RE: Burlington Quarry Extension – Nelson Response to JART’s Comments on the Visual Impact Assessment
OUR FILE 9135D

**Proposed Burlington Quarry Expansion
JART COMMENT SUMMARY TABLE – Visual Impact Assessment**

VISUAL IMPACT ASSESSMENT

PROPOSED EXTENSION OF THE BURLINGTON QUARRY

Figure 4
Assessed Views Photo Location Map

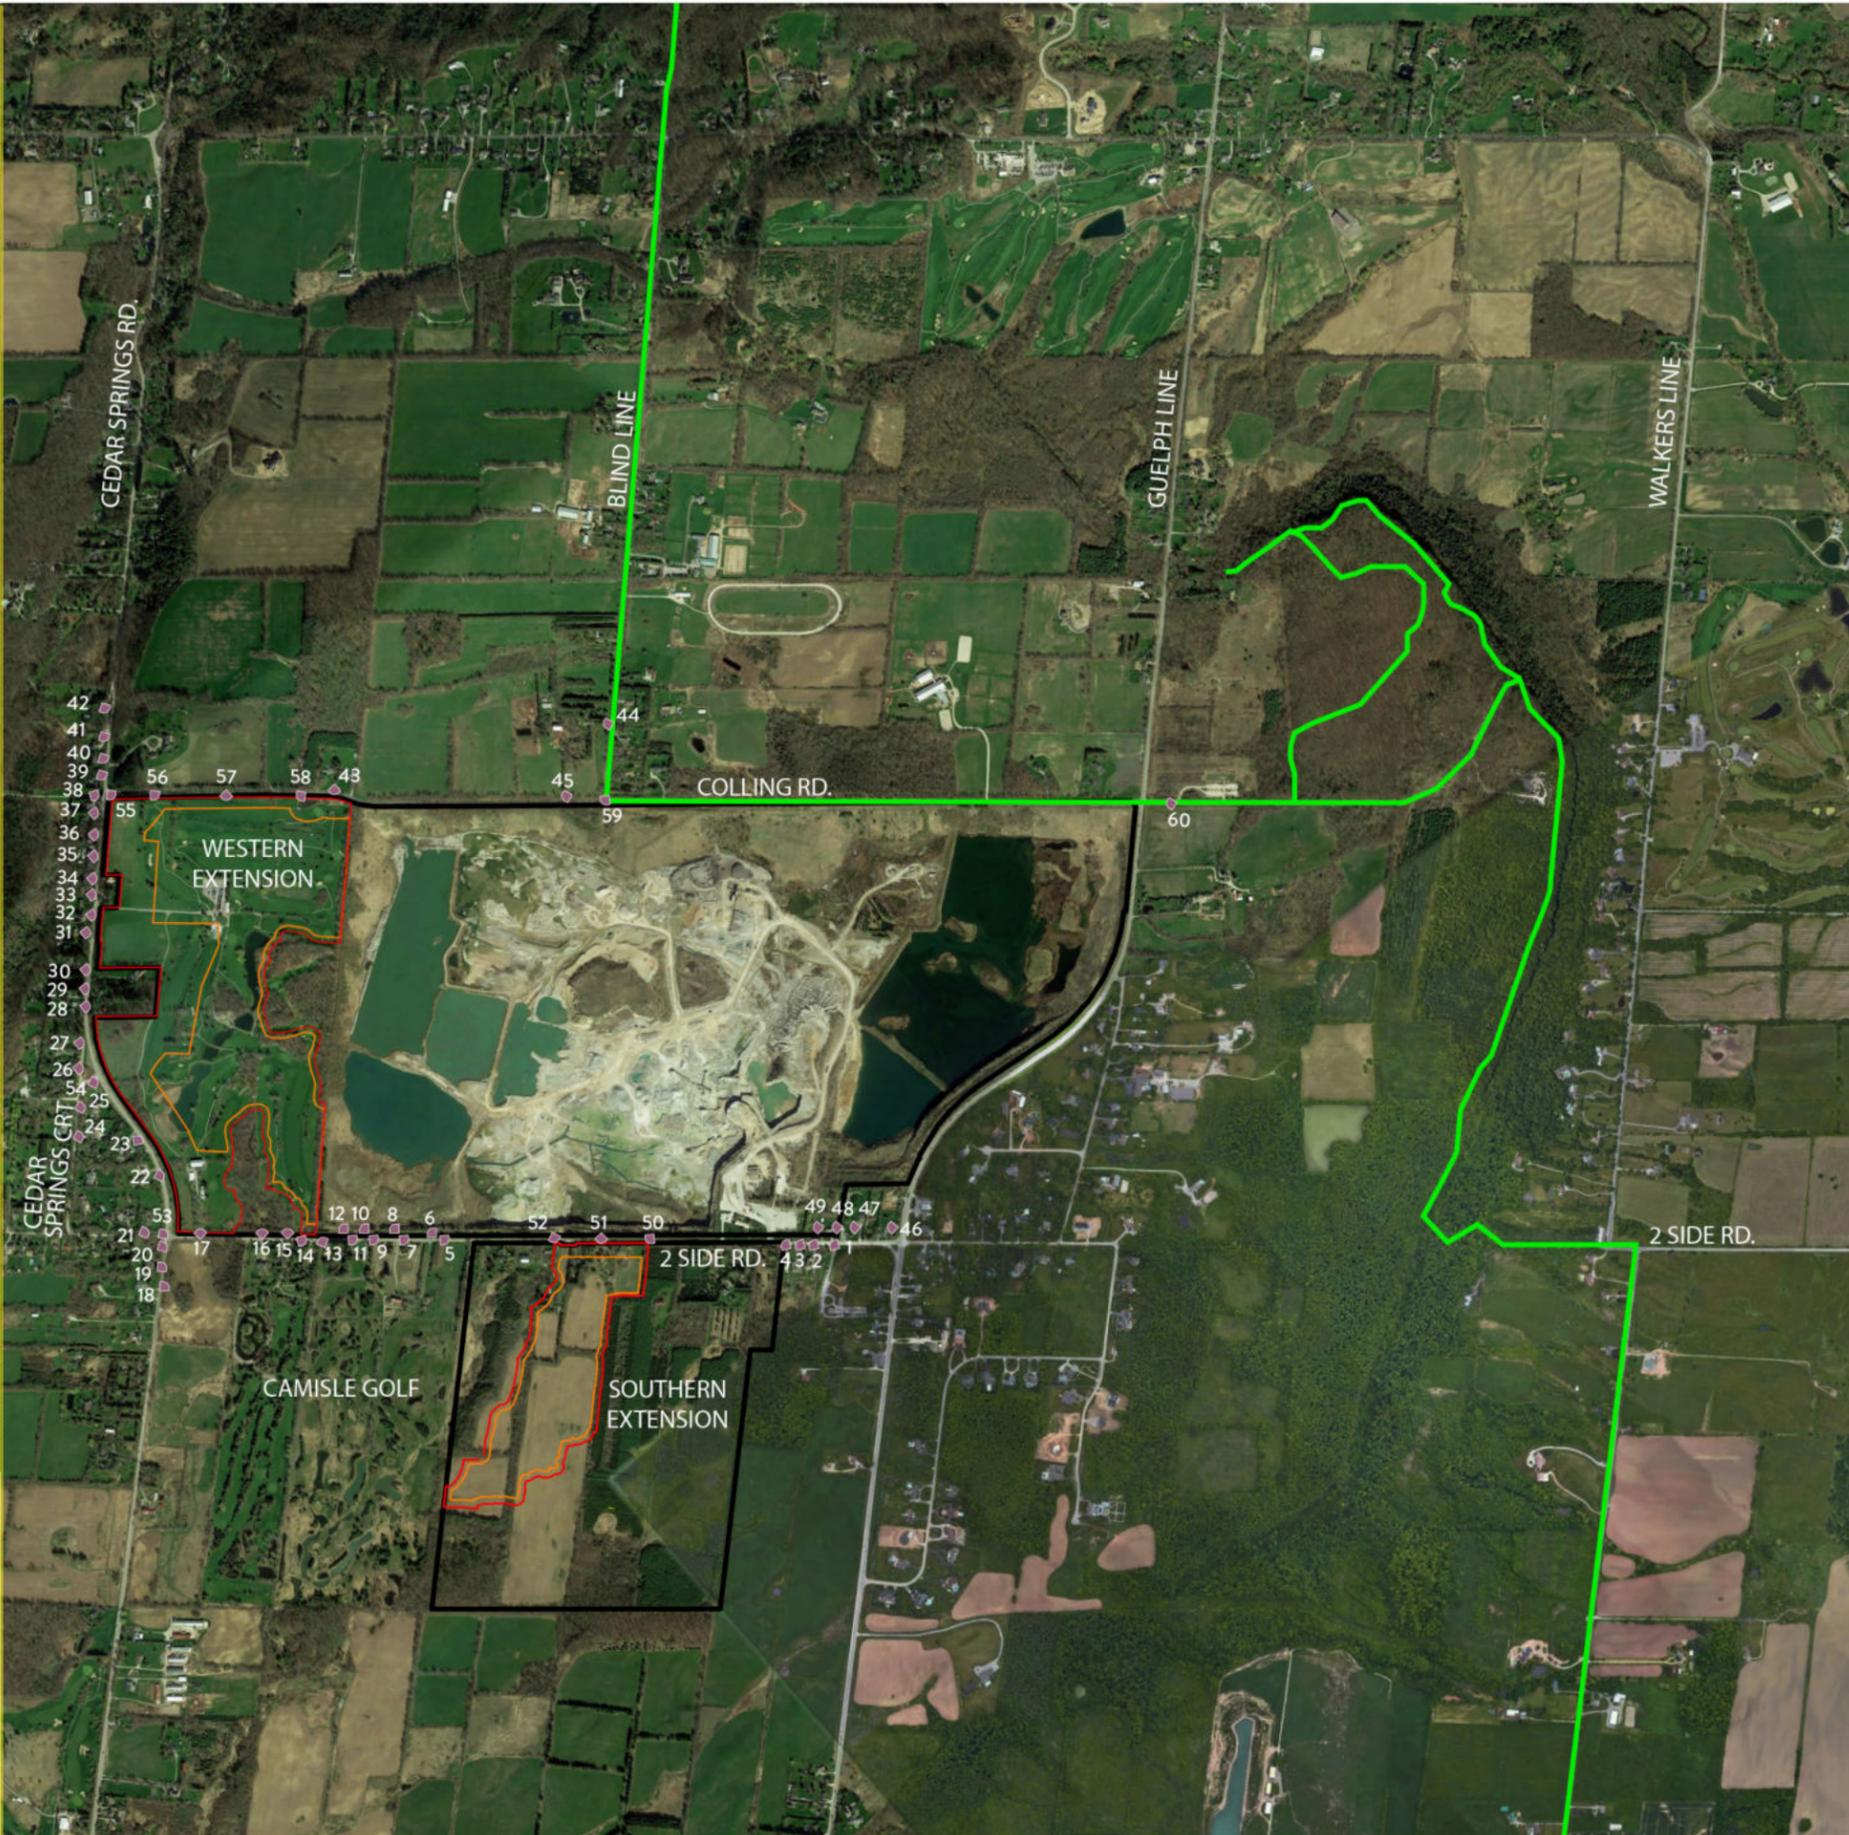
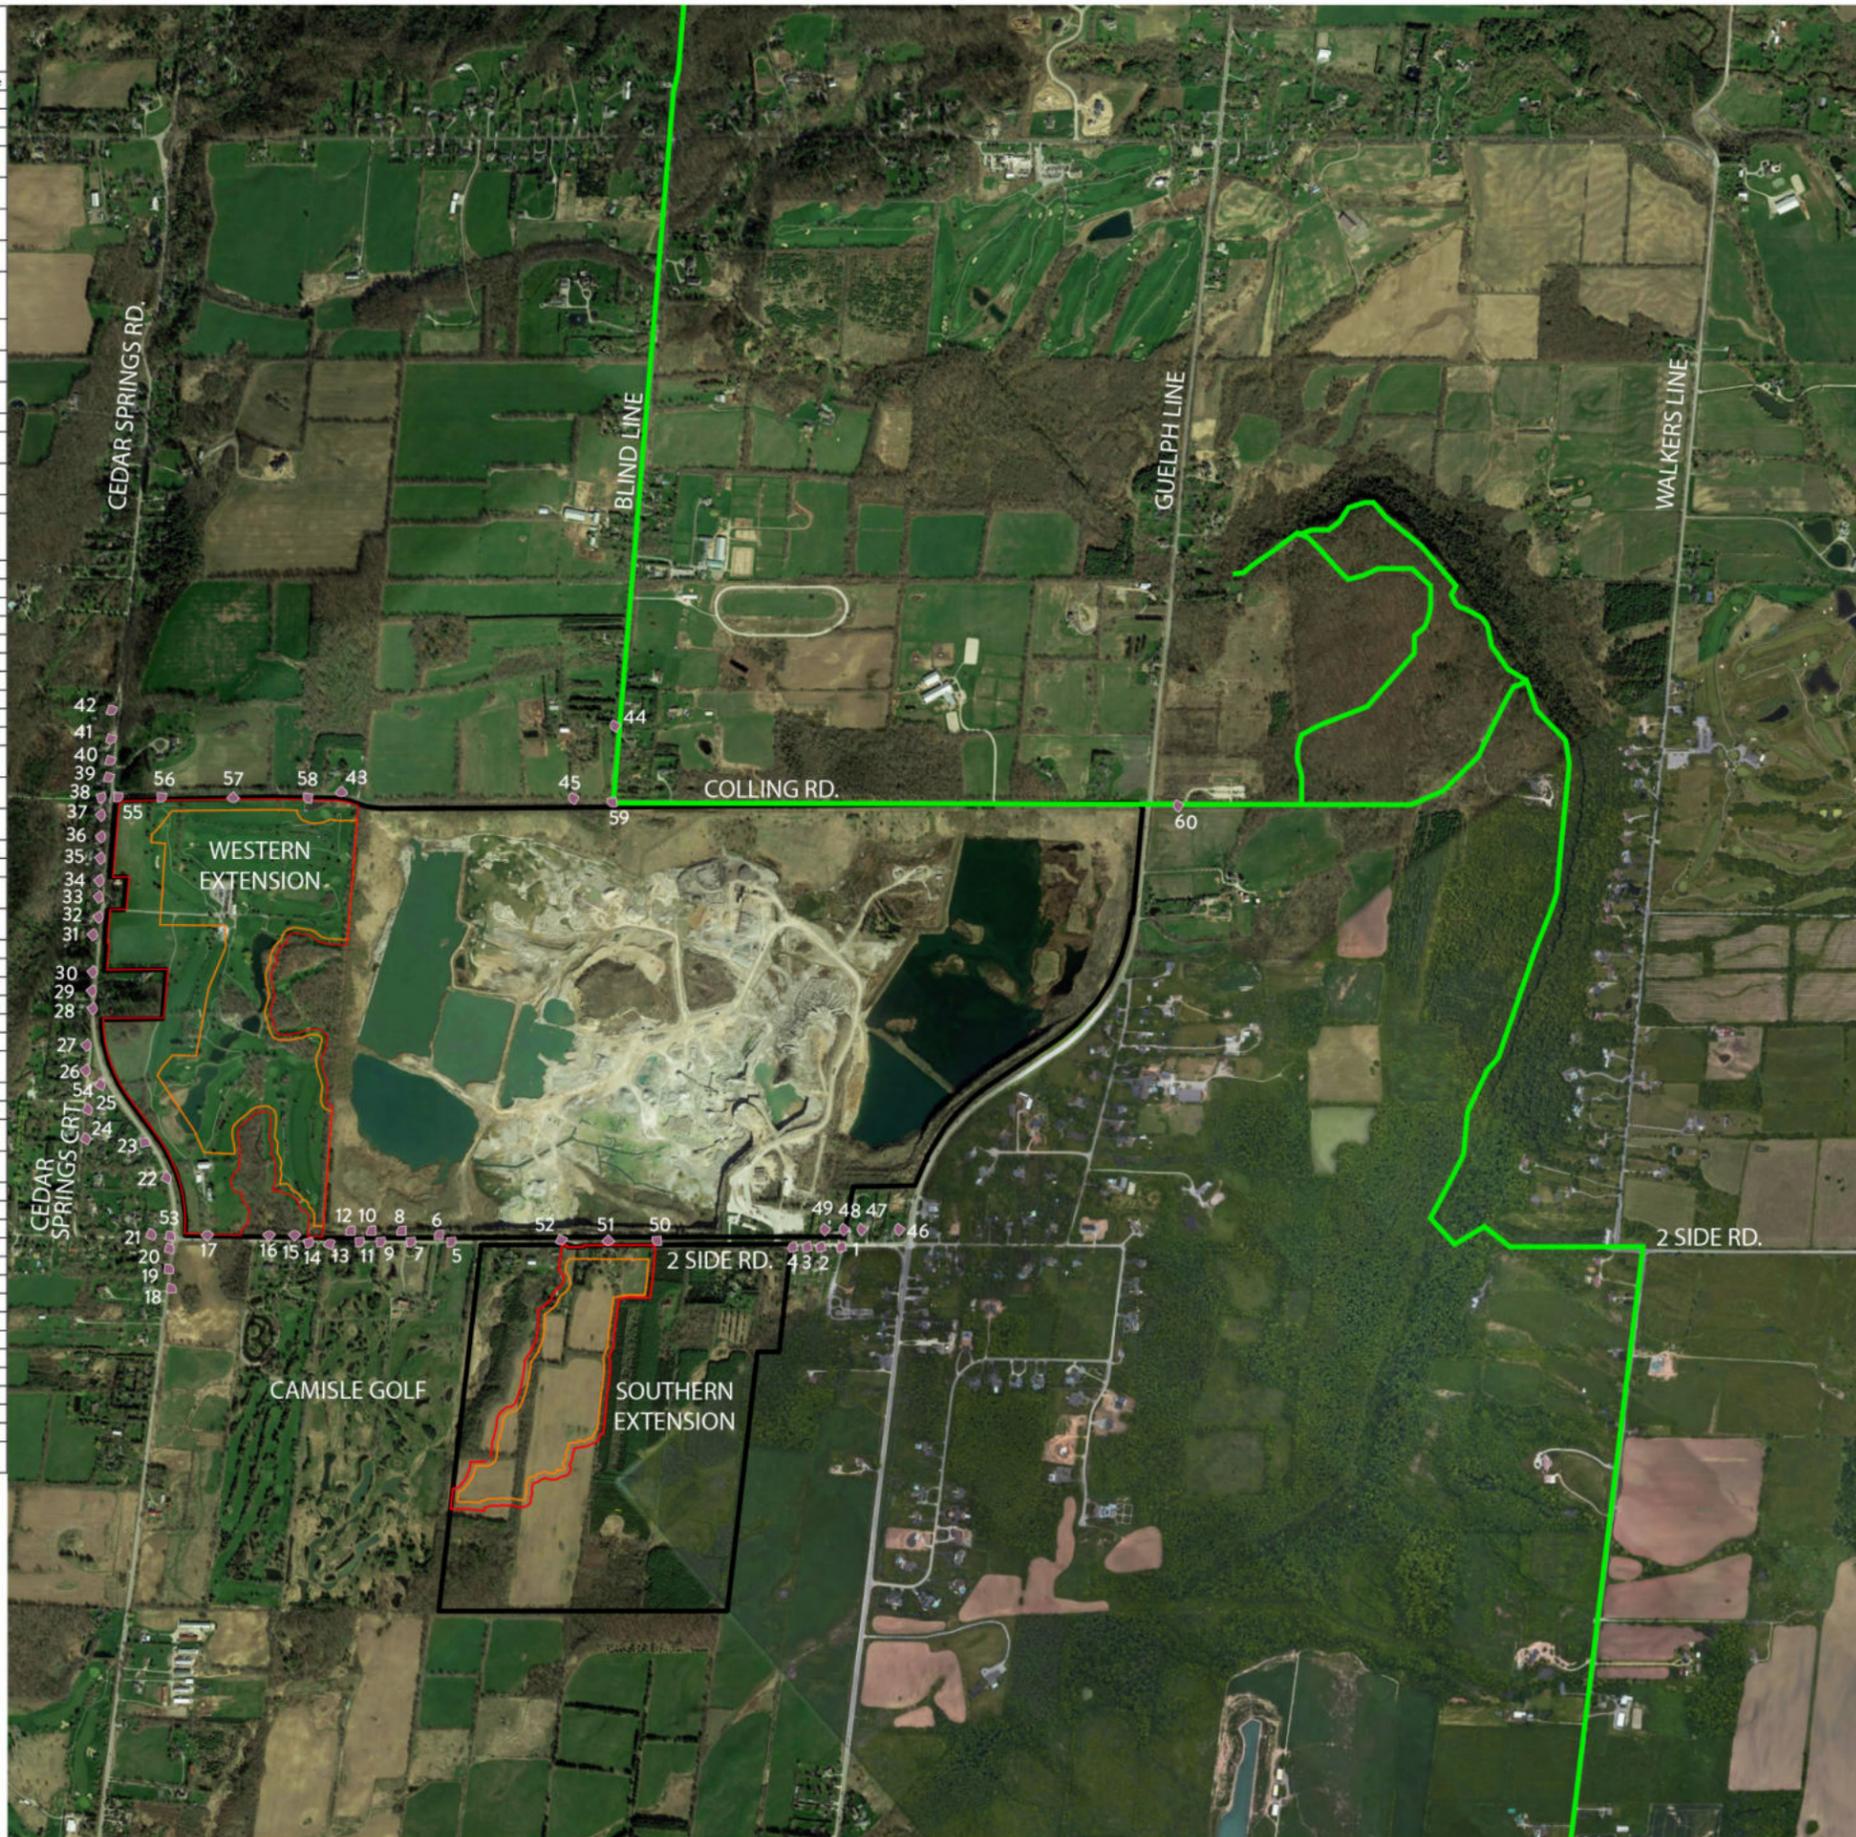
<ul style="list-style-type: none"> • Figure 4 Photo Location Map: VIAs must be accurate and replicable. This map is unreliable for determining the exact photo locations as there are a few errors in symbol placement and direction. This can be addressed with minor corrections (i.e. #21, 24, 25, 32) and by adding GPS and other details to the Photo Record. Label quarry extension names, road names, Bruce Trail route, and golf courses for reference on this map. 	<p>Receptors have been adjusted. Labels have been added.</p> <p>See updated report dated June 2021.</p>	
<ul style="list-style-type: none"> • Viewpoints: The following additional viewpoints are required to fully assess views from public roads, public lands, and the Bruce Trail. Visibility or lack of visibility must be documented in the Photo Record. <ul style="list-style-type: none"> o View from No. 2 Sideroad looking SW into South Quarry Extension o View from No. 2 Sideroad looking S into South Quarry Extension o View from No. 2 Sideroad looking SE into South Quarry Extension o View from the intersection of Cedar Springs Road/No. 2 Sideroad looking N into West Quarry Extension o View along Cedar Springs Court access road looking NE into West Quarry Extension o View from intersection of Cedar Springs Road/Colling Road looking SE into West Quarry Extension o View from Colling Road looking SE into West Quarry Extension o View from Colling Road looking S into West Quarry Extension o View from Colling Road looking SW into West Quarry Extension o View from Bruce Trail/intersection of Colling Road/Blind Line looking W into West Quarry Extension o Photo 13 - shift orientation to the north to document more of the existing roadside vegetation at the eastern limit of the West Quarry Extension 	<p>Photo receptors have been added and shifted as suggested.</p> <p>See updated report dated June 2021.</p>
